Comments on Granite's Responses to the Utah DAQ Via Letters Dated July 4 and July 16, 2024

I am providing the following comments after a careful review of Granite's responses to the DAQ's various Requests for Information (RFIs), including its additional air dispersion modeling using Weather Research Forecasting (WRF) meteorological data.

Figure 8: Comparison of 10 m height temperature between observations and WRF model results for SLC weather station from 2021 to 2023.

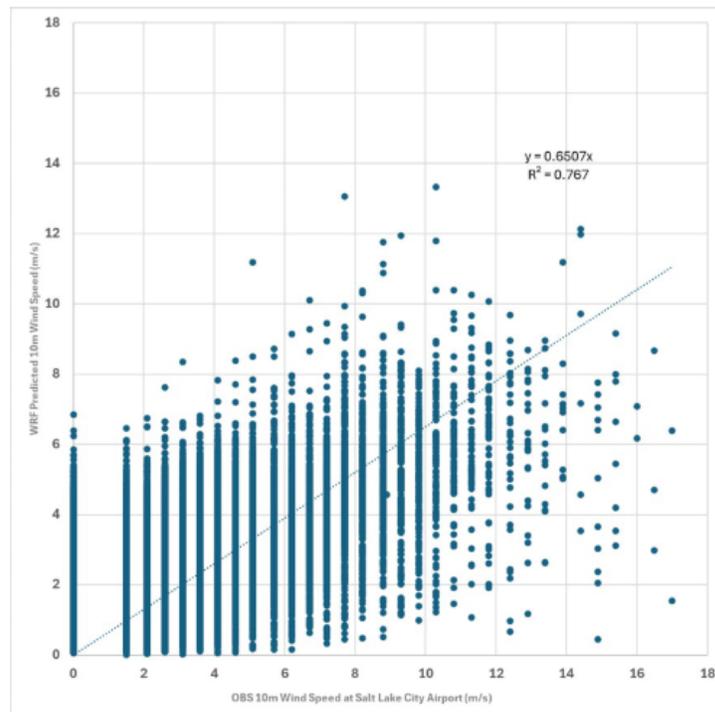
(a) The validation of the current model with SLC data for wind speed ($R^2 = 0.77$) as presented by Granite's consultant is not acceptable. In fact, the graphical presentation of this in Figure 8 of the modeling report, reproduced below, shows that even with very well defined geometry information as well as direct SLC meteorological data used for the comparison, the WRF pseudo-meteorological predictions are very inaccurate and subject to large errors at the SLC airport. We have no confidence, given these results, that the WRF model as currently used is providing useful or accurate data for use in AERMOD at the far more complex mine site.

In addition, I am not persuaded that the WRF model is acceptable given its better correlation for ambient temperatures ($R^2 = 0.98$), given that the temperature is a much more insensitive parameter.

Therefore, DAQ should ask Granite to explain how the SLC validation for wind speed can be improved. Specifically, and at a minimum, Granite should re-model using a spatial resolution of 444 meters (which is 1/3 of the 1.33 km resolution and the next higher level of spatial resolution in WRF) instead of the 1.33 km currently used. Not only will this likely improve the SLC validation, the 444 meter resolution is warranted given the complex topography at the mine site itself, which is not resolved well at the 1.33 km spatial scale. The 444 meter resolution would be much more reflective of canyon topography and winds, and would likely result in additional throughput reductions in order to avoid further NAAQS violations.

In addition, Granite should determine if any of the model physics options listed in Section 2.2 of the SLR July 4, 2024 modeling report should also be improved in order to further improve the SLC wind speed comparison.
